TXDOT PREFERRED PRACTICES FOR STEEL UPDATE

Gregory Turco, M.S.E., PE TxDOT Bridge
Division

3 Draft 2018 Revisions

Draft 2018 Revisions - 2.2.4.1 Dapped Webs

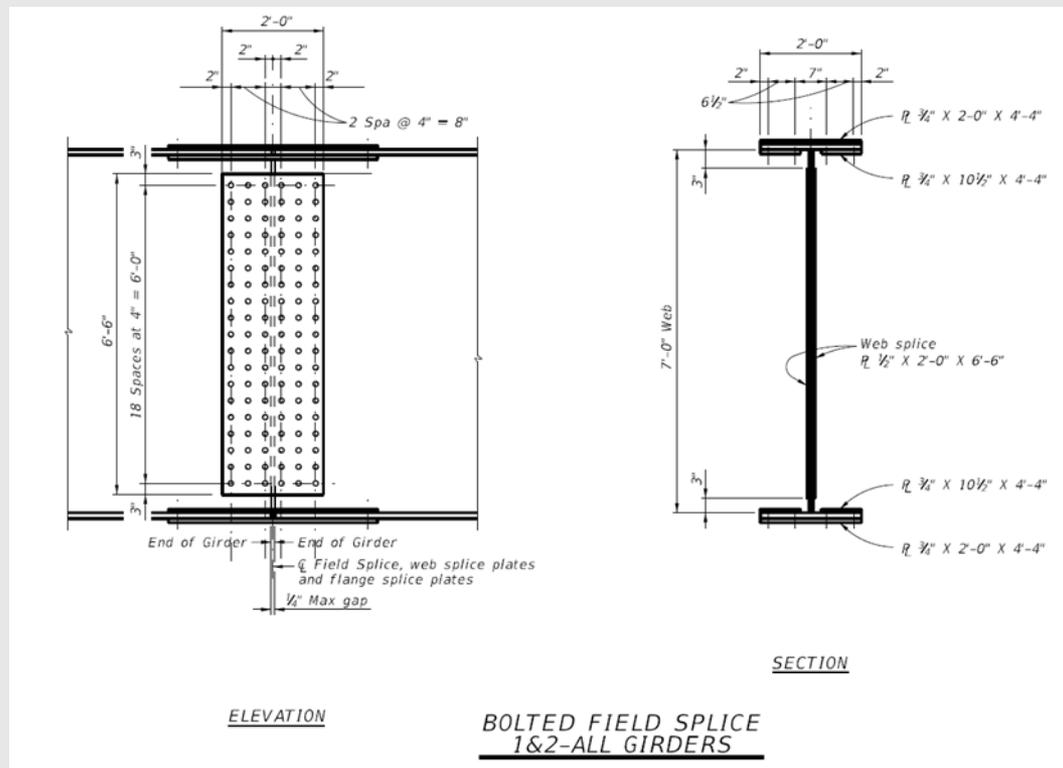
- Suggest dapping if difference in approach span depth and steel girder depth is $>1.5'$ for aesthetic reason (Will remain in document).
- Adding language to consider the extra fabrication cost of dapping and look at other alternatives to prevent the need for a dap.
- In below case, would the earwall have mostly obscured tall bearing seat buildups if the steel plate girder wasn't dapped?

Draft 2018 Revisions - 2.4.2. Webs (For Tub Girder Sections)

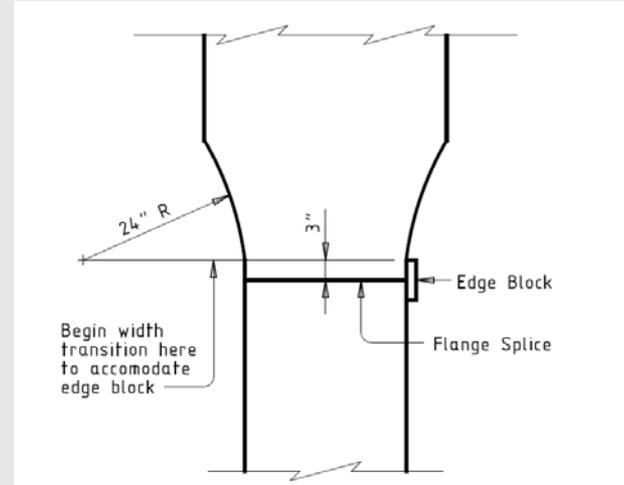
- Currently refers to same web recommendations as for plate girders.
- In some cases dapped and severely skewed end tub girders have to be re-designed per fabricator request.
- Add language to not dap tub girders with severely skewed ends? Or eliminate completely?

Draft 2018 Revisions - 3.2.1 Use of Edge Blocks for Radiographs

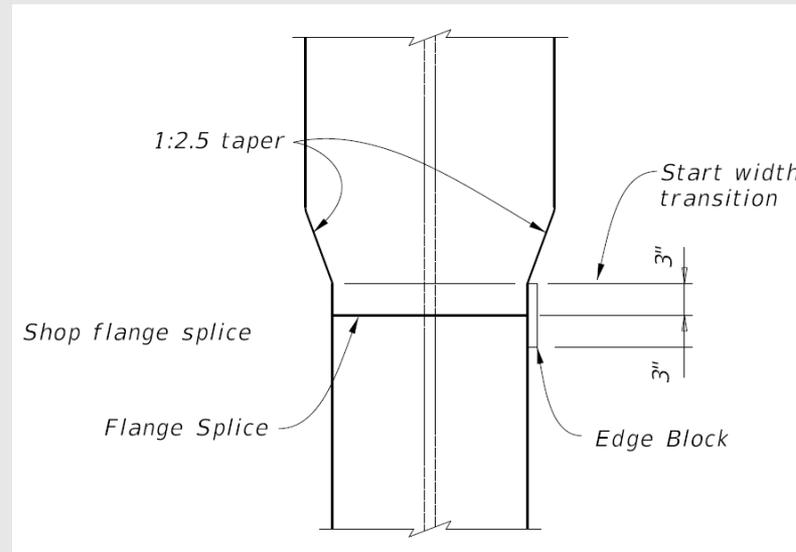
- Currently shows a radial width transition at flange width transition

- Update to show tapered detail from TxDOT SGMD Standard
